**RE: Objections to “Seigler Springs North” commercial cannabis cultivation, UP 21-17,
IS 21-18.**

Subject: Review of May 19, 2023, Hydrology Report and Drought Management Plan – UP 21-17, Seigler Springs North Cultivation Project

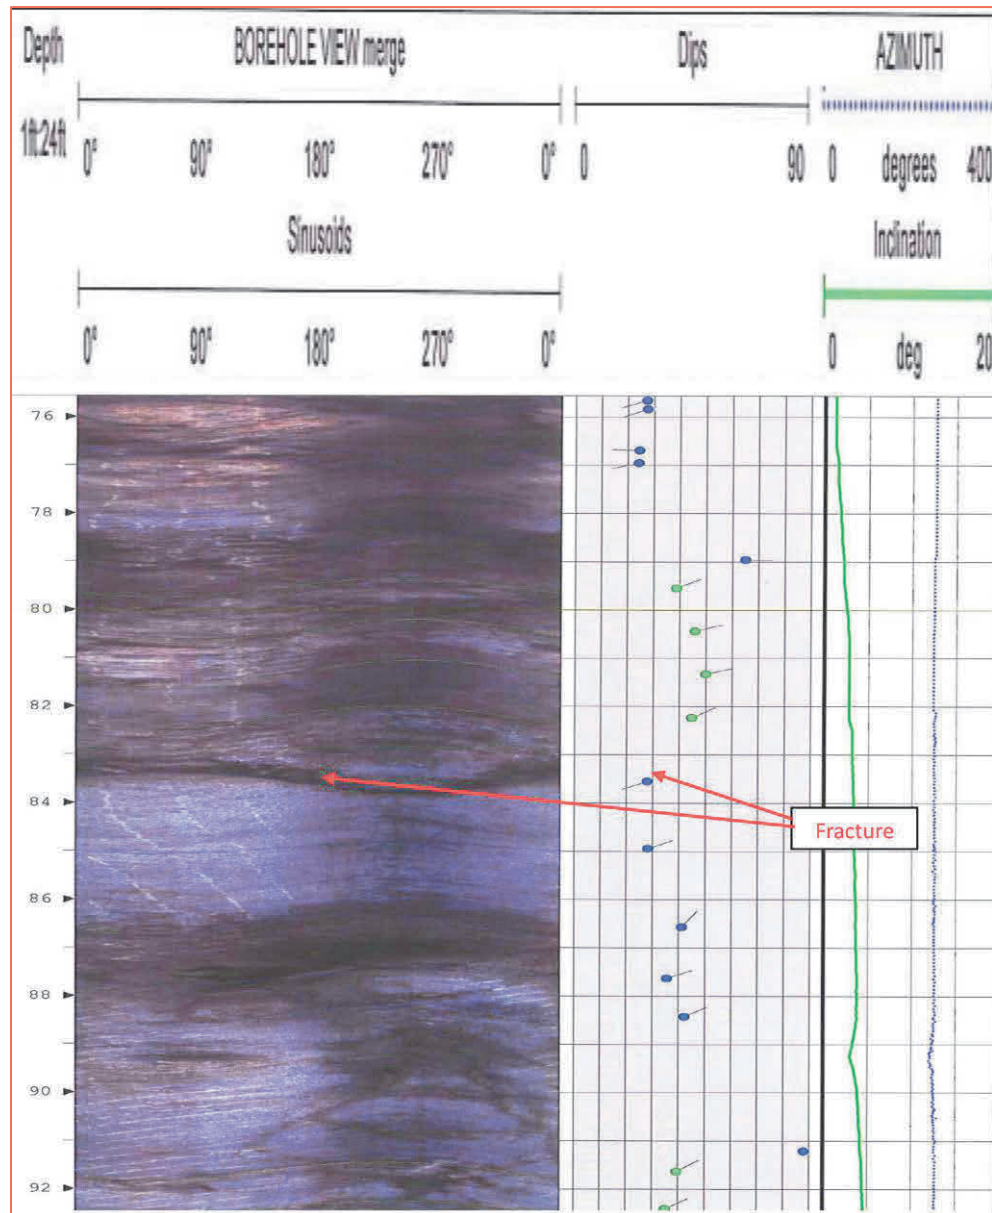
To assess the amount of fractures that contain water, a test hole should be completed, and an acoustic televiewer (to assess number and orientation of fractures) and heat pulse flow meter conducted to assess which fractures transmit water. An example of both these methods are shown in Figures 3 (acoustic/optical televiewer) and 4 (heat pulse televiewer). As seen in these figures, although many fractures may be present, only a small amount are producing water. At the site these measurements were taken near Quincy California, recognition of these features was critical in protecting a supply well for a small hotel.

Based on the information provided above, the actual groundwater storage within the aquifer beneath the proposed project is significantly less than reported and possibly orders of magnitude lower. If this information is not assessed, significant impacts could occur through the drying up of fractures as is discussed further in Comments 4 and 5.

Figure 4. Example of heat pulse flow meter showing which fractures produce water.

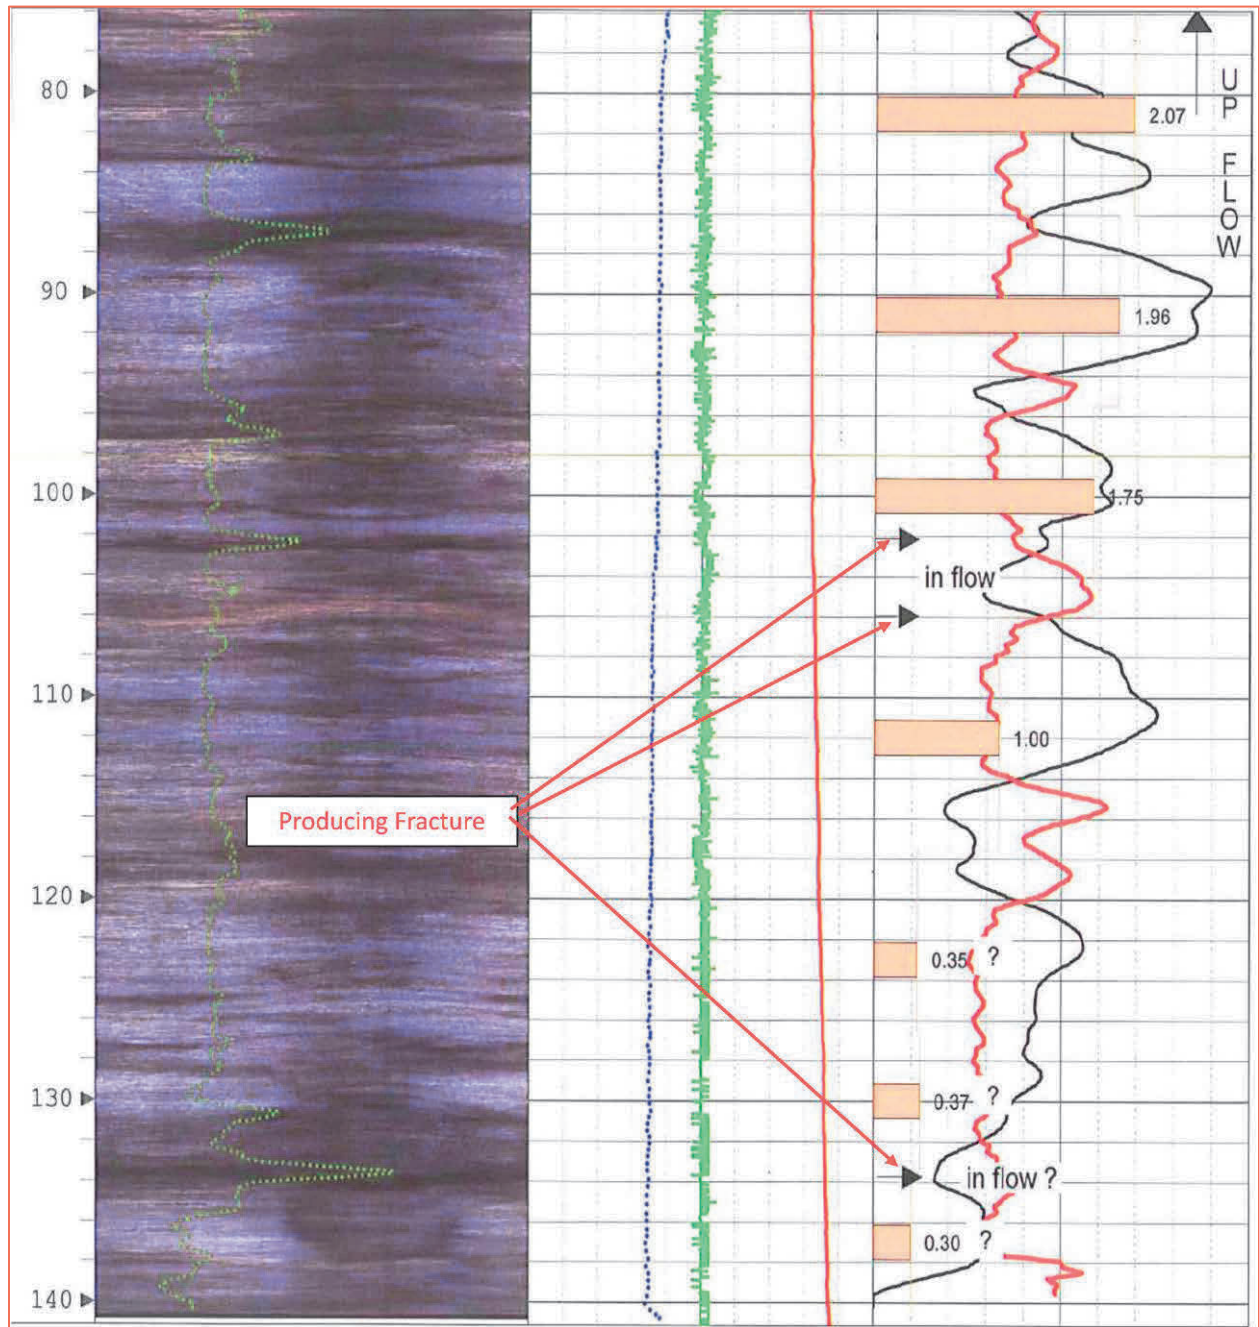
To provide an accurate assessment of cumulative impacts to the surrounding area, first the orientation and dip of the producing fractures must be known. This information can be obtained by use of the optical televiwer and heat pulse flow meter discussed for Comment 3. For example, if the producing fractures trend towards the northeast or southeast, then pumping on the proposed project well could have significant impact to the existing wells at the Mountain of Attention property.

Figure 4-1 – Regional context and primary evacuation corridor.

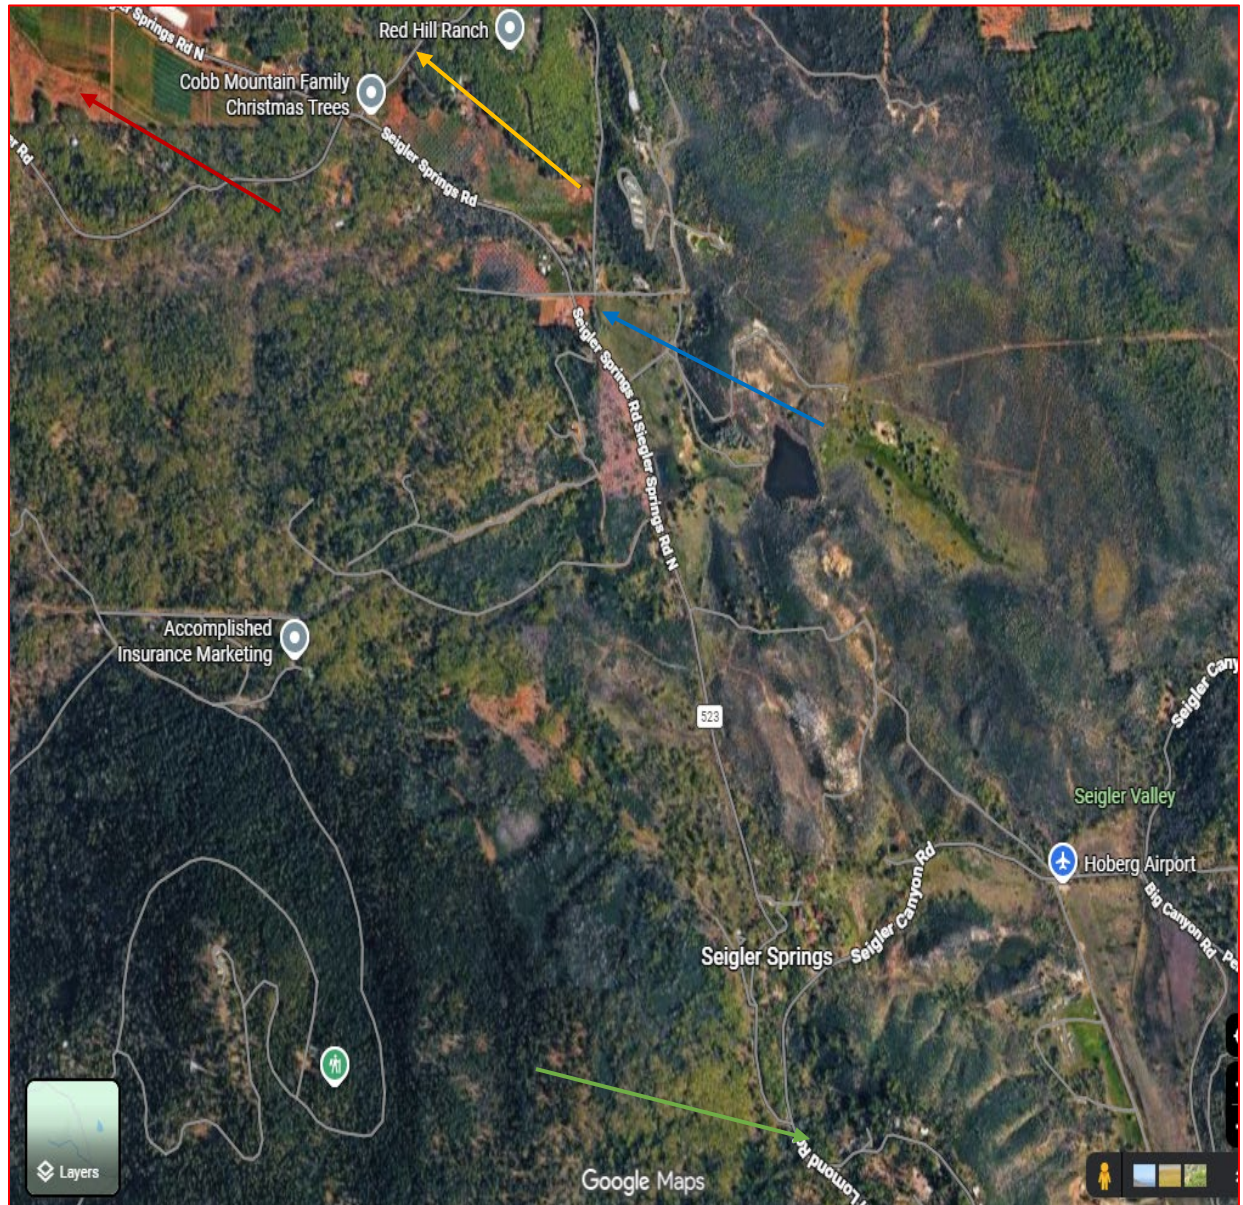
Unlike urban transportation systems that provide multiple evacuation options, this area depends upon a limited rural road network. During a wildfire emergency, these roads must simultaneously accommodate evacuating residents, project employees, visitors, retreatants, emergency responders, utility crews, and mutual aid resources.

Figure 6-3 – 90-degree turn affecting opposing traffic. Major choke point

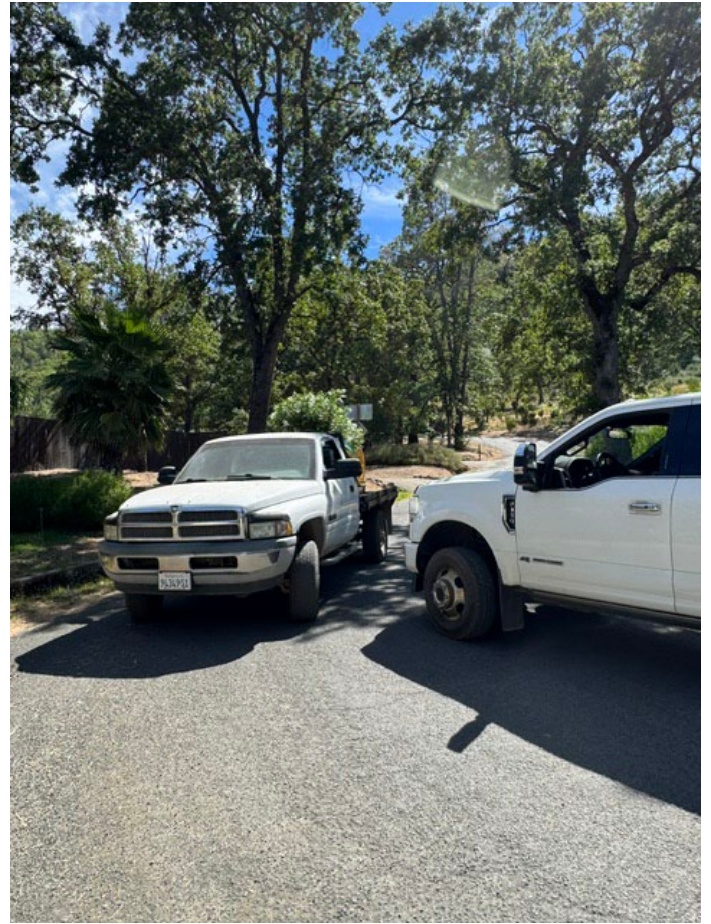
Representative 90-degree turn illustrating roadway geometry and vehicle maneuvering characteristics.
